**Addendum # 1**  
**File # 16-0499 (REBID)**  
**Energy Efficiency Lighting Project**

**PROJECT:** City of Duluth Energy  
Efficiency Lighting Project

G&M Project No. 84493

**DATE:**  
August 30, 2016

1  
E103

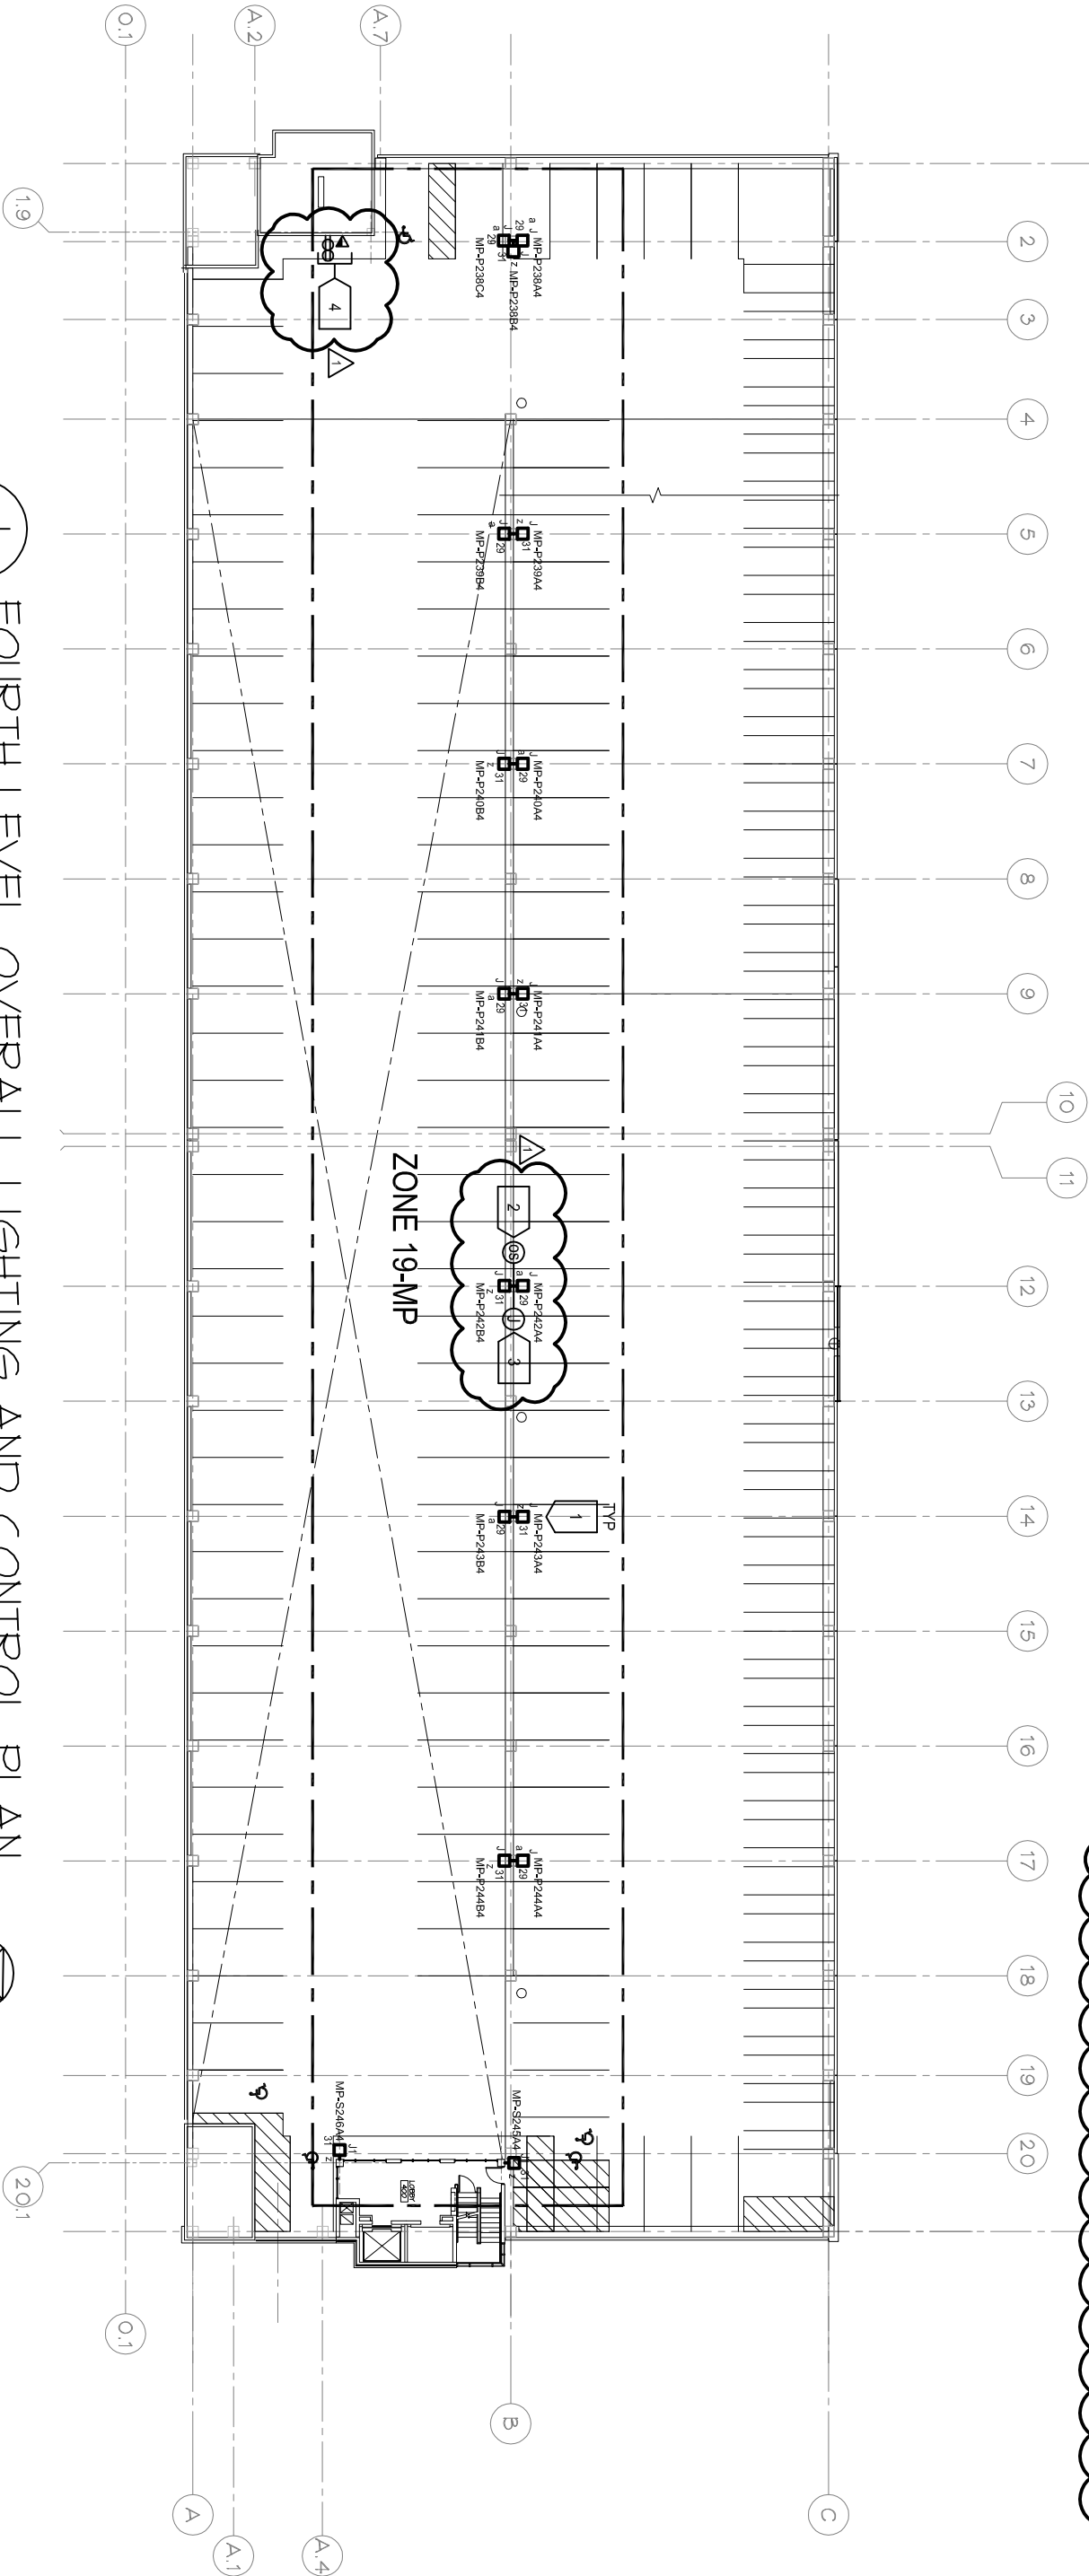
4. Sheet E103
  - Add numbered notes 5 and 6 as shown clouded on plan.
  - Add occupancy sensors as shown clouded on plan.
  - Revise lighting control matrix as shown clouded on plan.

- Revise numbered notes 1 and 2 as shown clouded on plan.
5. Sheet E104
  - Add numbered notes 2, 3 and 4 as shown clouded on plan.
  - Add occupancy sensors as shown clouded on plan.

- 5 PROVIDE WIRELESS OCCUPANCY SENSOR(S) ASSOCIATED WITH RESPECTIVE ZONE(S) FOR CONTROL. COORDINATE EXACT LOCATION AND QUANTITIES WITH LIGHTING CONTROL MANUFACTURER.

- 6 PROVIDE DEDICATED 120V, 20A QUAD RECEPTACLE (CONNECTED TO NEAREST 120/208V PANEL WITH 20A SPARE BREAKER) AND VOICE/DATA OUTLET FOR WIRELESS LIGHTING CONTROL SYSTEM GATEWAY (ECHELON LUMEWAVE SYSTEM). VERIFY EXACT LOCATION OF GATEWAYS WITH OWNER PRIOR TO ROUGH-IN.

1 FOURTH LEVEL OVERALL LIGHTING AND CONTROL PLAN  
E104 SCALE: 0' = 32'

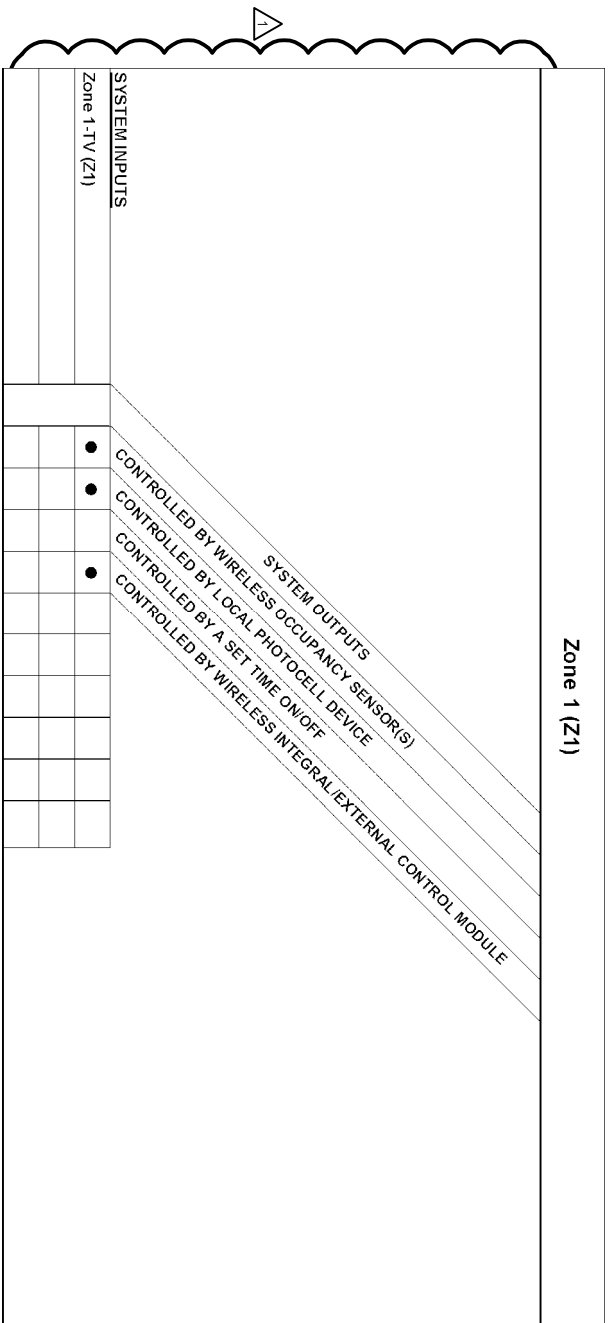
- Revise numbered note 1 as shown clouded on plan.
  - Revise lighting control matrix as shown clouded on plan.

- 1 PROVIDE WIRELESS CONTROL MODULE MOUNTED EXTERNAL TO EACH TYPE 'J' OR 'J1' LIGHT FIXTURE AS MANUFACTURED BY ECHELON CONTROLS LUMEWAVE SERIES OR APPROVED EQUIVALENT.
- 2 PROVIDE WIRELESS OR HARD-WIRED OCCUPANCY SENSOR(S) ASSOCIATED WITH RESPECTIVE ZONE(S) FOR CONTROL AS MANUFACTURED BY ECHELON CONTROLS OR APPROVED EQUIVALENT. COORDINATE EXACT LOCATION AND QUANTITIES WITH LIGHTING CONTROL MANUFACTURER.
- 3 PROVIDE WIRELESS PHOTOCELL AS MANUFACTURED BY ECHELON CONTROLS LUMEWAVE SERIES OR APPROVED EQUIVALENT. VERIFY EXACT LOCATION PRIOR TO INSTALLATION.
- 4 PROVIDE DEDICATED 120V, 20A QUAD RECEPTACLE (CONNECTED TO NEAREST 120/208V PANEL WITH 20A SPARE BREAKER) AND VOICE/DATA OUTLET FOR WIRELESS LIGHTING CONTROL SYSTEM GATEWAY (ECHELON LUMEWAVE SYSTEM). VERIFY EXACT LOCATION OF GATEWAYS WITH OWNER PRIOR TO ROUGH-IN.

E105 SCALE: 0' NTS

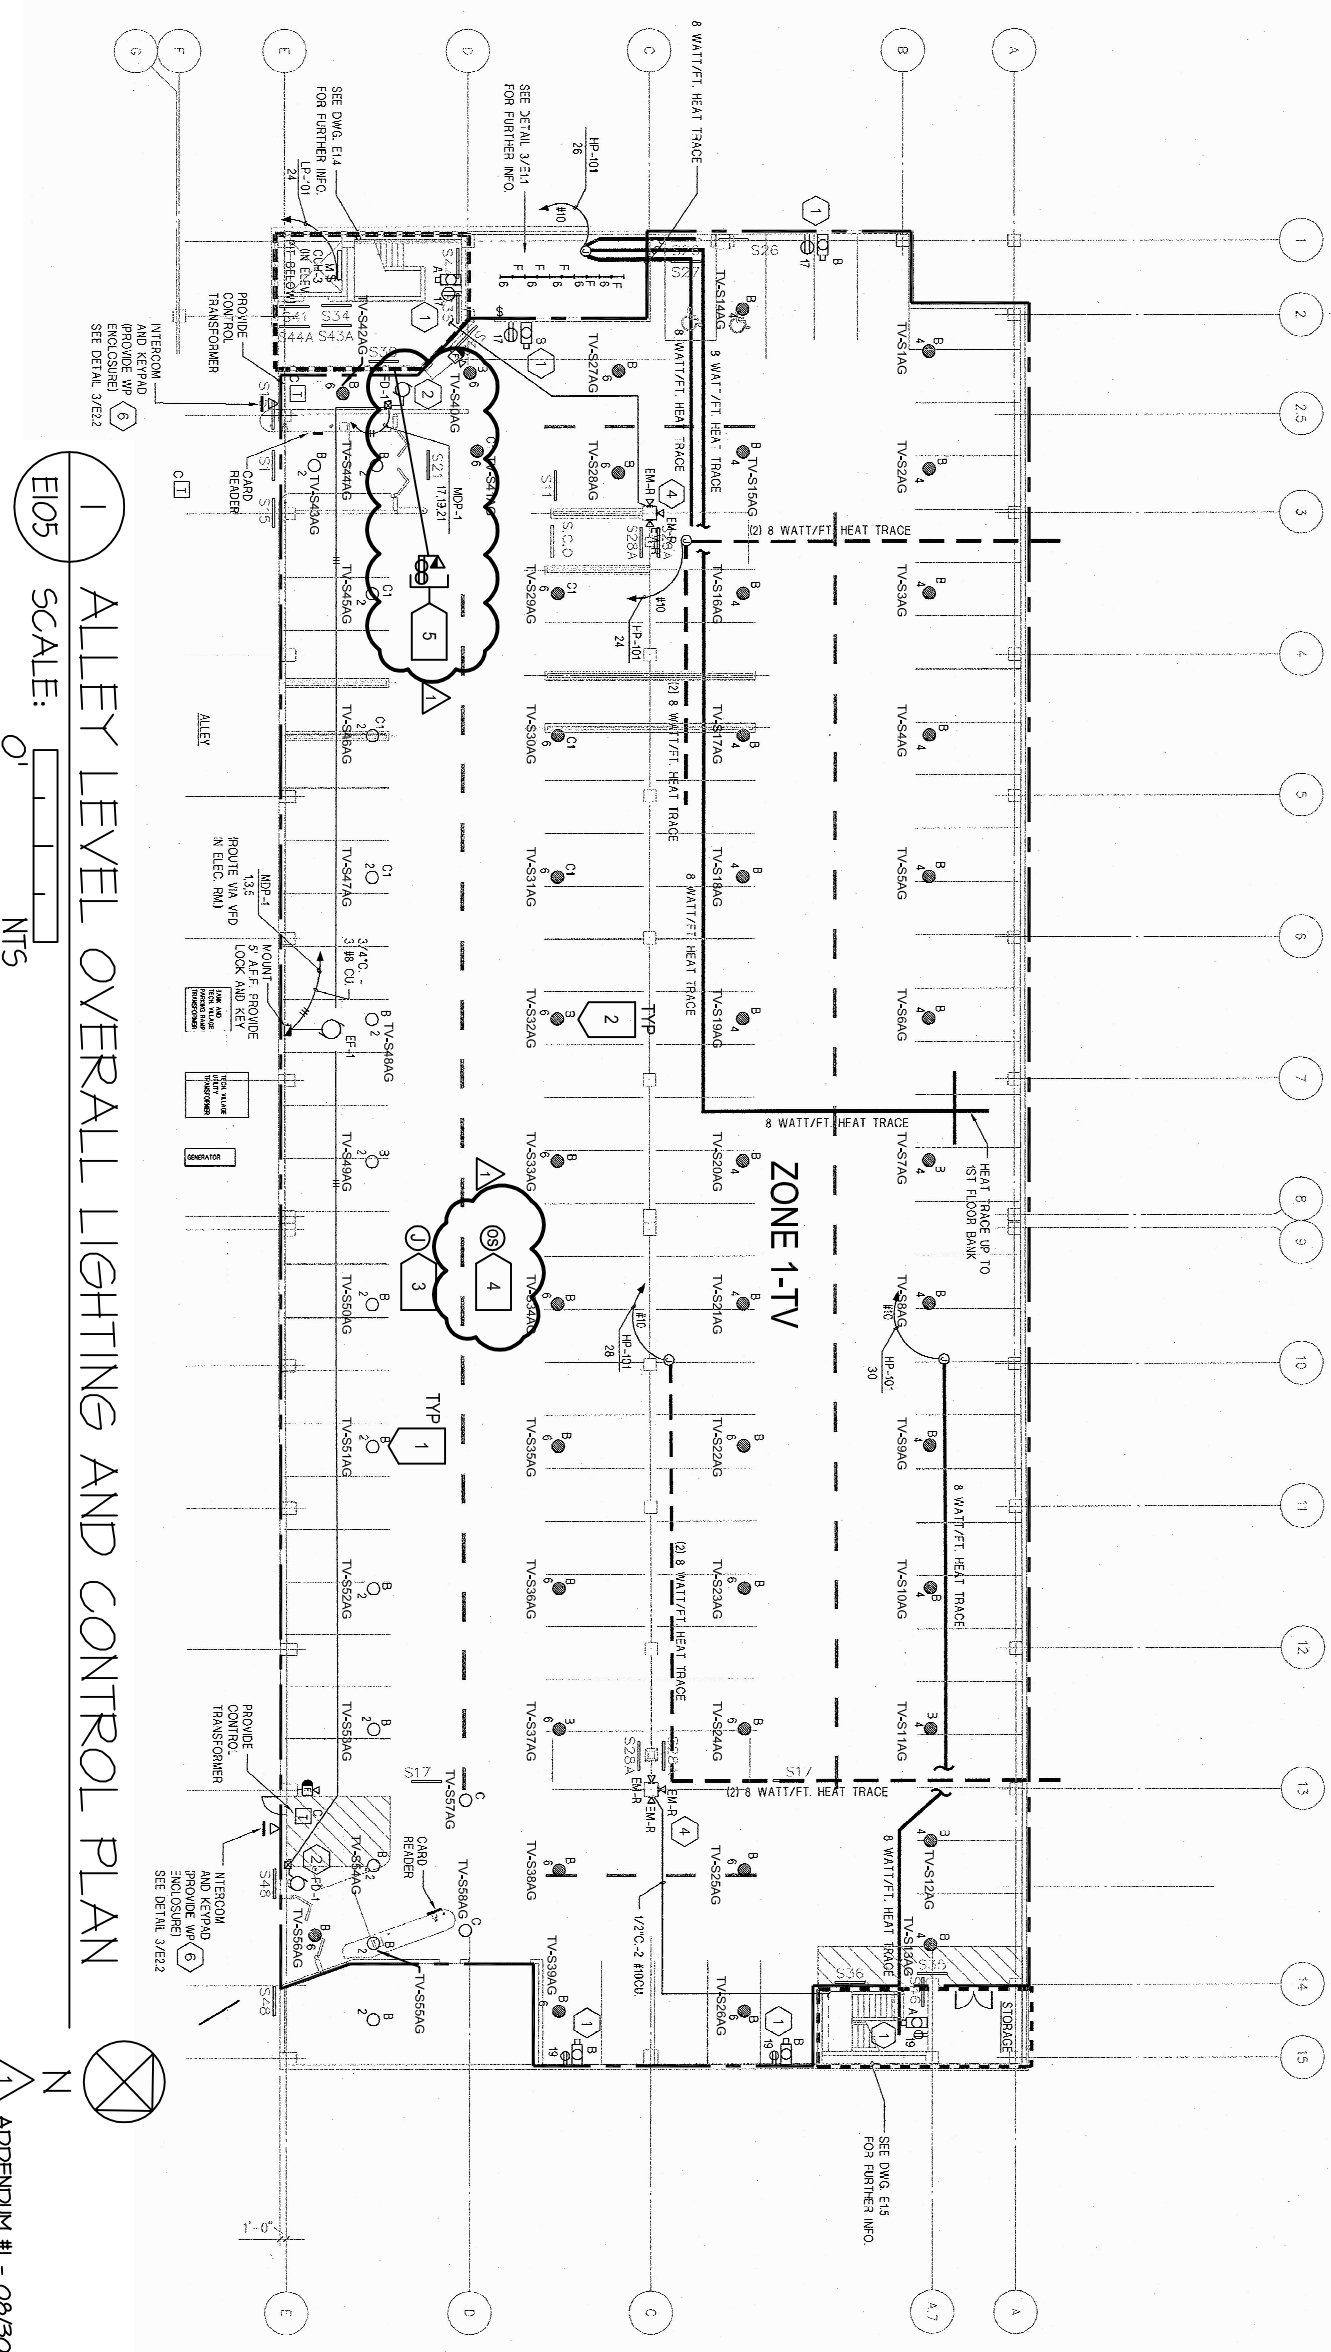
| 6.  | Sheet E105 | <ul style="list-style-type: none"><li>• Add numbered notes 4 and 5 as shown clouded on plan.</li><li>• Add occupancy sensors as shown clouded on plan.</li><li>• Revise lighting control matrix as shown clouded on plan.</li><li>• Revise numbered note 1 as shown clouded on plan.</li></ul>        |

- 4 PROVIDE WIRELESS OCCUPANCY SENSOR(S) ASSOCIATED WITH RESPECTIVE ZONE(S) FOR CONTROL AS MANUFACTURED BY ECHELON, LUMEWAVE SERIES OR APPROVED EQUIVALENT. COORDINATE EXACT LOCATION AND QUANTITIES WITH LIGHTING CONTROL MANUFACTURER.

- 5 PROVIDE DEDICATED 120V, 20A QUAD RECEPTACLE (CONNECTED TO NEAREST 120/208V PANEL WITH 20A SPARE BREAKER) AND VOICE/DATA OUTLET FOR WIRELESS LIGHTING CONTROL SYSTEM GATEWAY (ECHELON LUMEWAVE SYSTEM). VERIFY EXACT LOCATION OF GATEWAYS WITH OWNER PRIOR TO ROUGH-IN.

E107

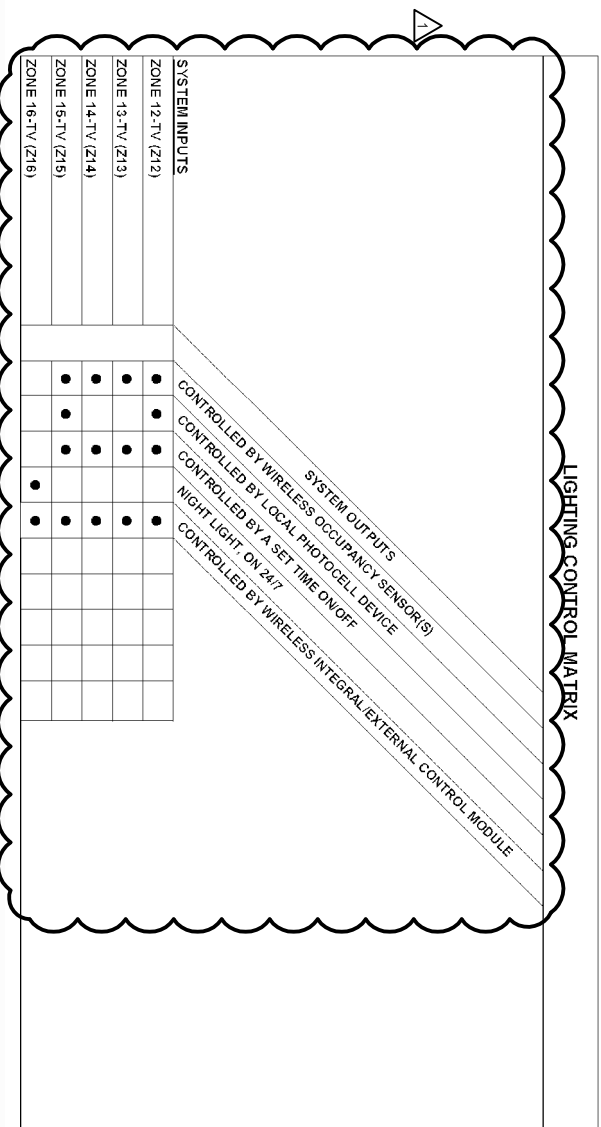
| 8.  | Sheet E107 | <ul style="list-style-type: none"><li>• Add numbered notes 5 and 6 as shown clouded on plan.</li><li>• Add occupancy sensors as shown clouded on plan.</li><li>• Revise lighting control matrix as shown clouded on plan.</li><li>• Revise numbered notes 1 and 2 as shown clouded on plan.</li></ul> |

- 5 PROVIDE WIRELESS OCCUPANCY SENSOR(S) ASSOCIATED WITH RESPECTIVE ZONE(S) FOR CONTROL. COORDINATE EXACT LOCATION AND QUANTITIES WITH LIGHTING CONTROL MANUFACTURER.

- 6 ROVIDE DEDICATED 120V, 20A QUAD RECEPTACLE (CONNECTED TO NEAREST 120/208V PANEL WITH 20A SPARE BREAKER) AND VOICEDATA OUTLET FOR WIRELESS LIGHTING CONTROL SYSTEM GATEWAY (ECHELON LUMEWAVE SYSTEM). VERIFY EXACT LOCATION OF GATEWAYS WITH OWNER PRIOR TO ROUGH-IN.

E108

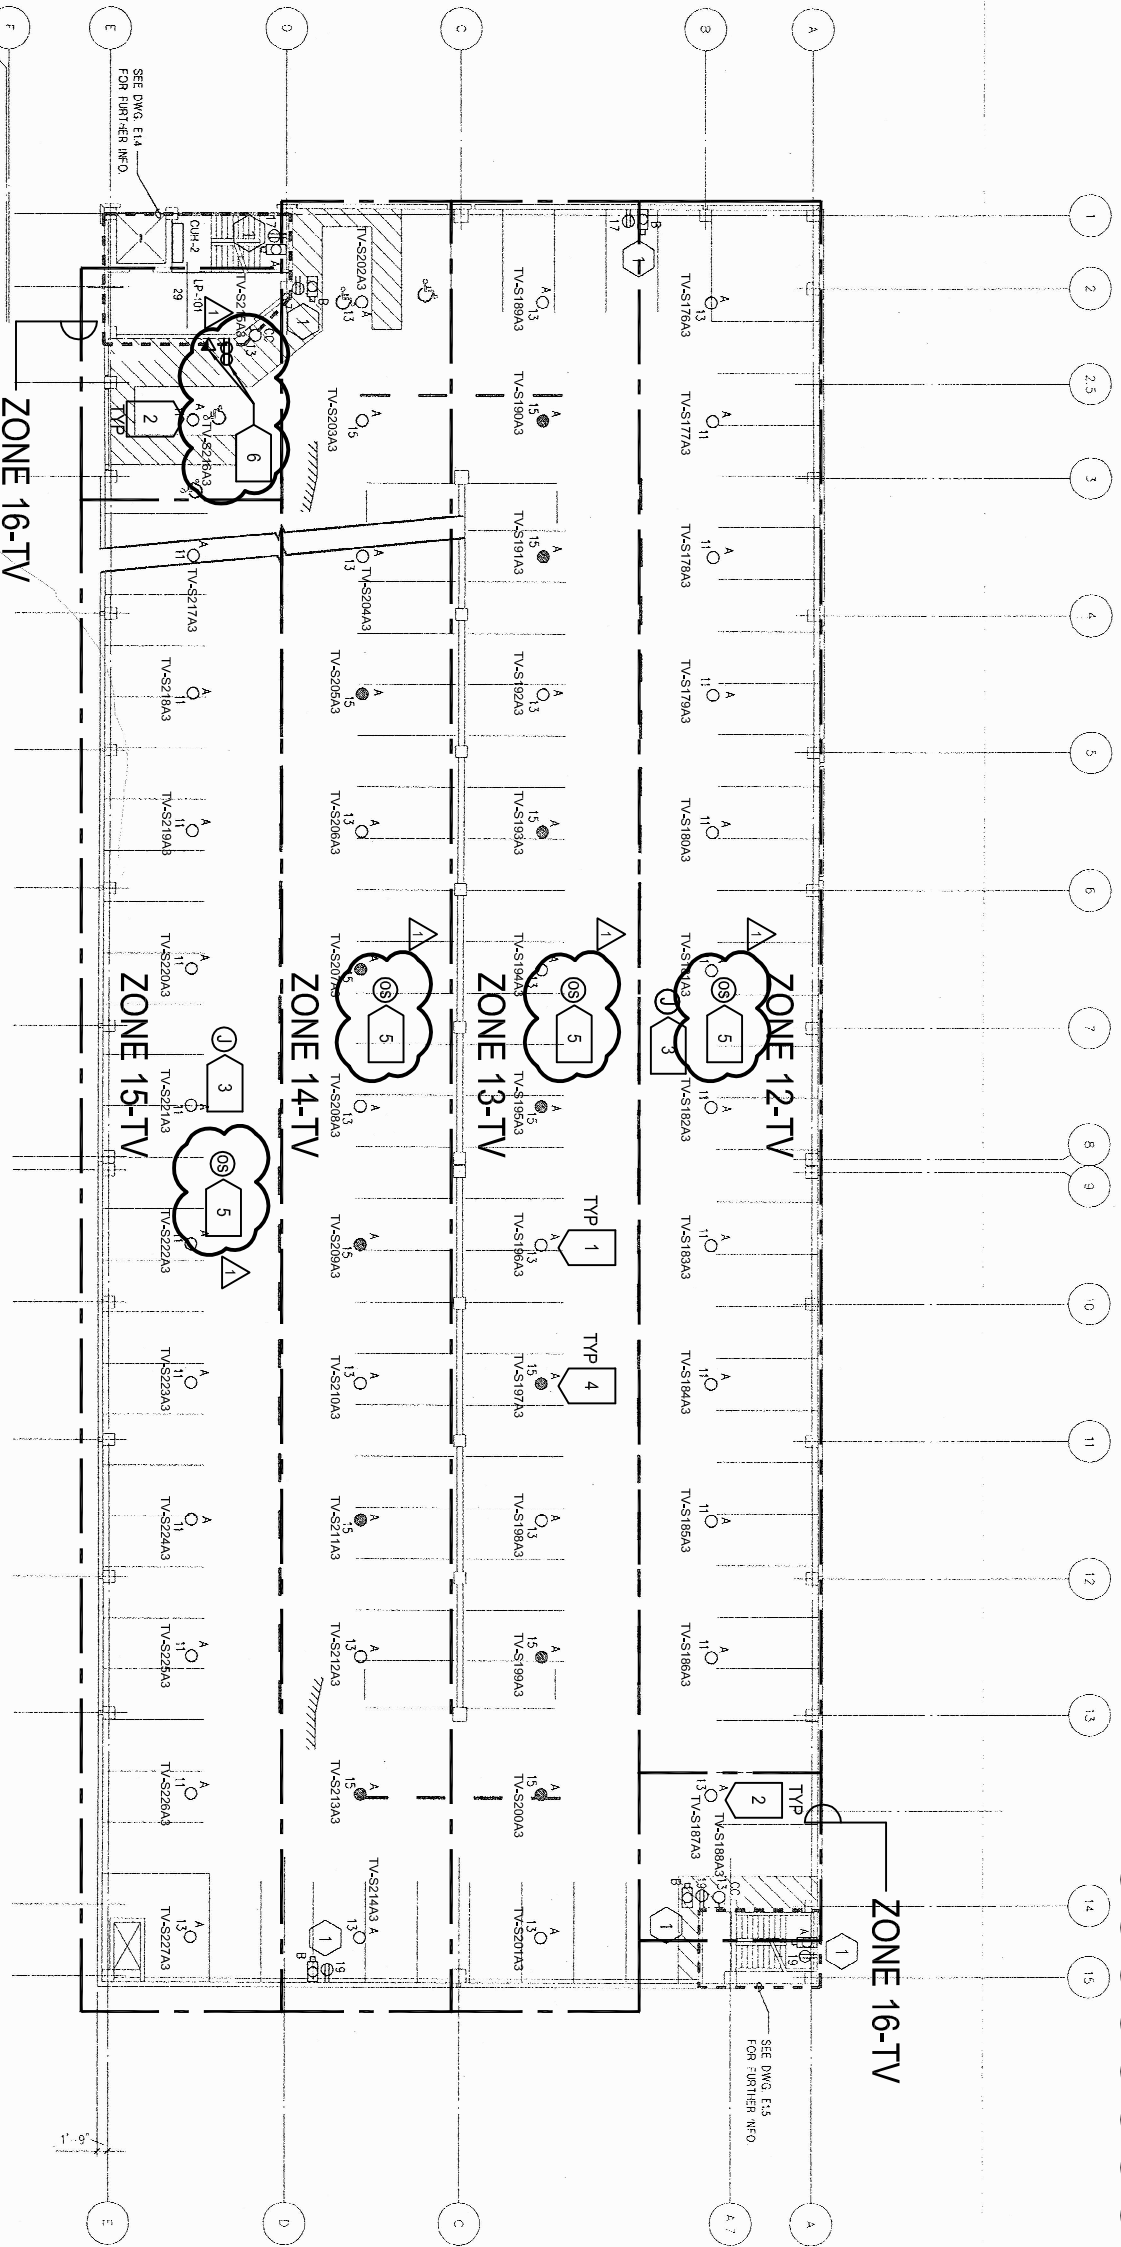
| 9.  | Sheet E108 | <ul style="list-style-type: none"><li>• Add numbered notes 5 and 6 as shown clouded on plan.</li><li>• Add occupancy sensors as shown clouded on plan.</li><li>• Revise lighting control matrix as shown clouded on plan.</li><li>• Revise numbered notes 1 and 2 as shown clouded on plan.</li></ul> |

- 5 PROVIDE WIRELESS OCCUPANCY SENSOR(S) ASSOCIATED WITH RESPECTIVE ZONE(S) FOR CONTROL. COORDINATE EXACT LOCATION AND QUANTITIES WITH LIGHTING CONTROL MANUFACTURER.

- 6 ROVIDE DEDICATED 120V, 20A QUAD RECEPTACLE (CONNECTED TO NEAREST 120/208V PANEL WITH 20A SPARE BREAKER) AND VOICEDATA OUTLET FOR WIRELESS LIGHTING CONTROL SYSTEM GATEWAY (ECHELON LUMEWAVE SYSTEM). VERIFY EXACT LOCATION OF GATEWAYS WITH OWNER PRIOR TO ROUGH-IN.
